Planning Commission

Monday, August 3, 2026 - 6:00 PM

BLAZE MOBILE HOME PARK

RE: Blaze Mobile Home Park - Site Plan Review
SEH No. BALDW 146223

CSM COMMENTS

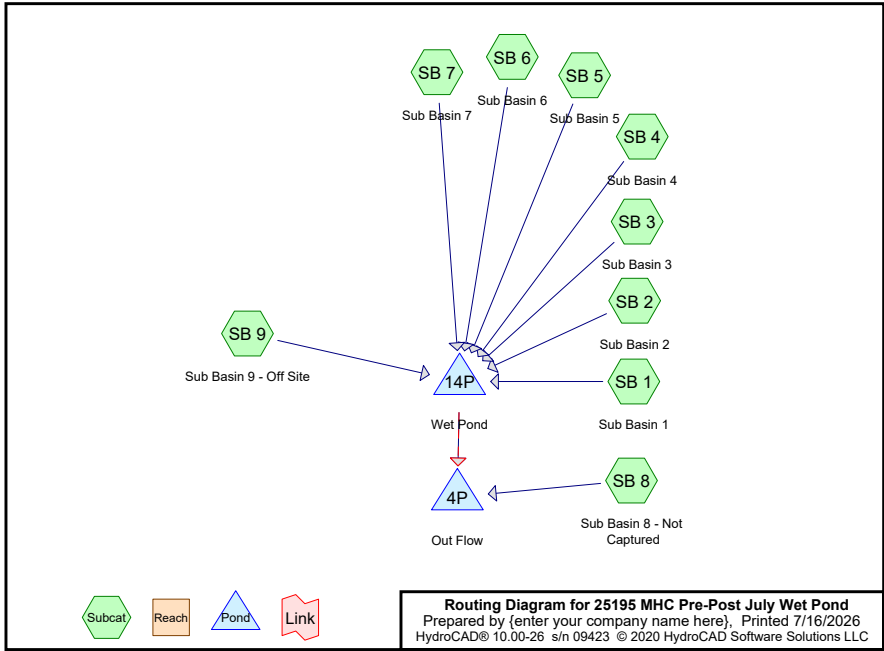
23. A CSM providing a separate lot for this development was determined by staff as the approach required, such that a new Conditional Use Permit (CUP) could be processed with new conditions from the original CUP issued for the development.
- 24. The setback lines on the CSM are not consistent with the setback lines indicated on the plans. Setback lines should be updated to be consistent on all documents.**
- 25. The current Village Treasurer position is vacant and signatory of the CSM will be provided by the Administrator. Remove "Kim Larson" from the CSM.**
26. Code § 620-17B also requires contours and the entire area contiguous to the proposed CSM be included but can be waived by the PC or Board, which could be appropriate for the submittal.
